**AREAS OF MODIFICATION BETWEEN APPROVED DRAINAGE GRADING PLAN AND ACTUAL AS-BUILT**

LOT 30 BLOCK 33 TRACT A UNIT B  
NORTH ALBUQUERQUE ACRES

Scale: 1" = 20'	Drawn By: DJP	Checked By: CLW	Job Number:	Date: OCT. 1995
<p><b>Drainage and Grading Plan</b></p> <p>JUN 25 1996</p>				<p><b>C-1</b></p> <p>SH. 1 OF 2</p>

Drainage and  
Grading Plan Information  
C-2  
SH. 2 OF 2

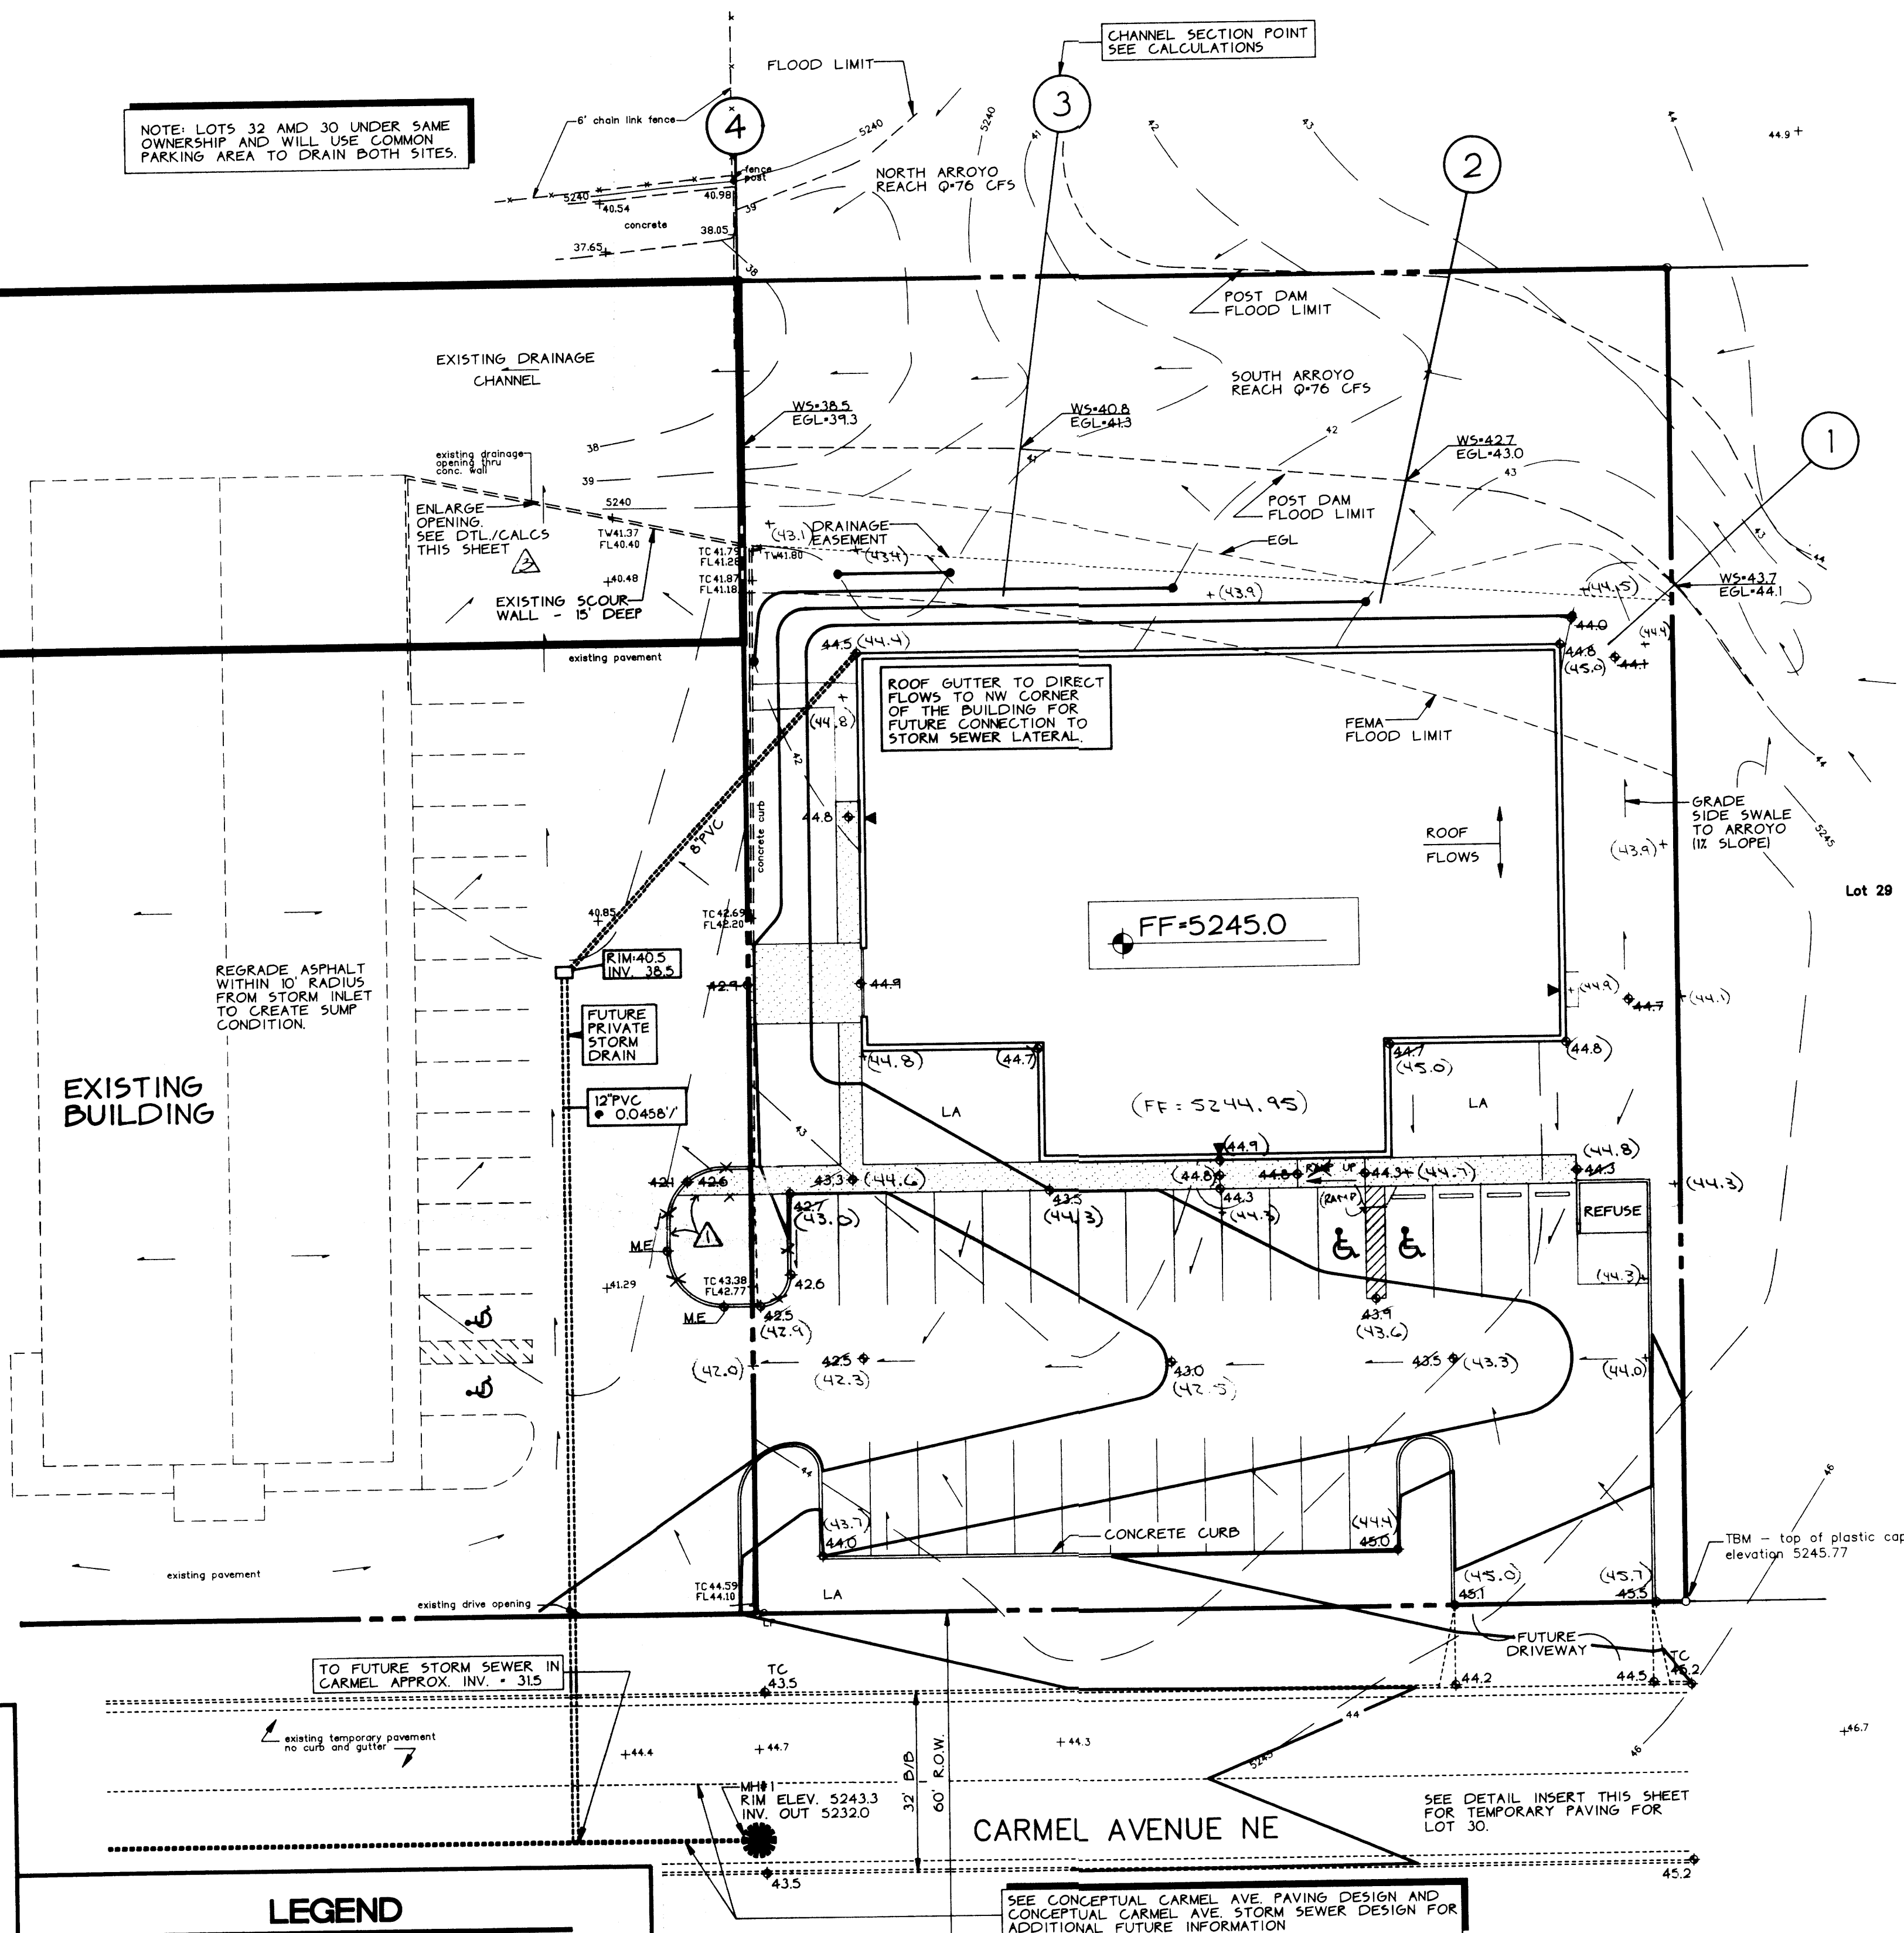
1. Curb / Walk / Landscaped area not constructed. Does not affect Drainage / Grading.
2. As-built pond elevations differ from approved drainage / grading plan. Required volume is available (see attached Pond As-Built Information and Calculations).
3. Enlargement of existing opening in concrete wall not constructed per plan. Due to temporary storage of this opening (future flows to be collected in future storm drain), analysis indicates that this will have minimal effect on the storage. Based on calculations, the peak discharge flows will back up to an approximate depth of 1'. This will not effect adjacent buildings.

I, Christopher L. Weiss, P.E. hereby certify that the as-built information shown is in substantial compliance with the approved drainage / grading plan.

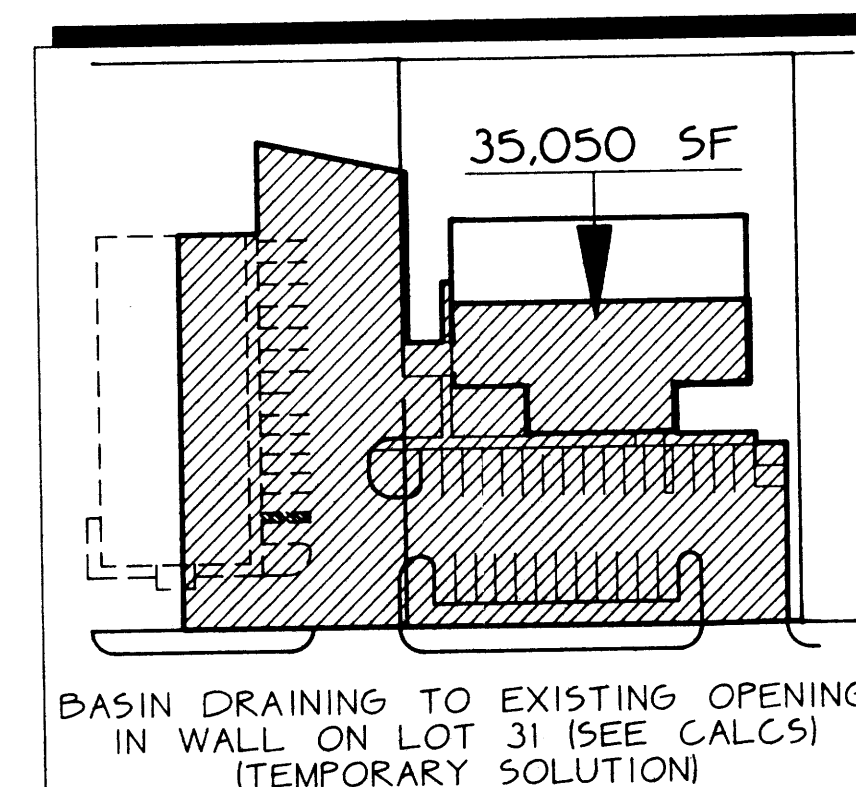
ENLARGE DRAINAGE OPENING  
IN CONC. WALL

BASIN DRAINING TO EXISTING OPENING  
IN WALL ON LOT 31 (SEE CALCS)  
(TEMPORARY SOLUTION)
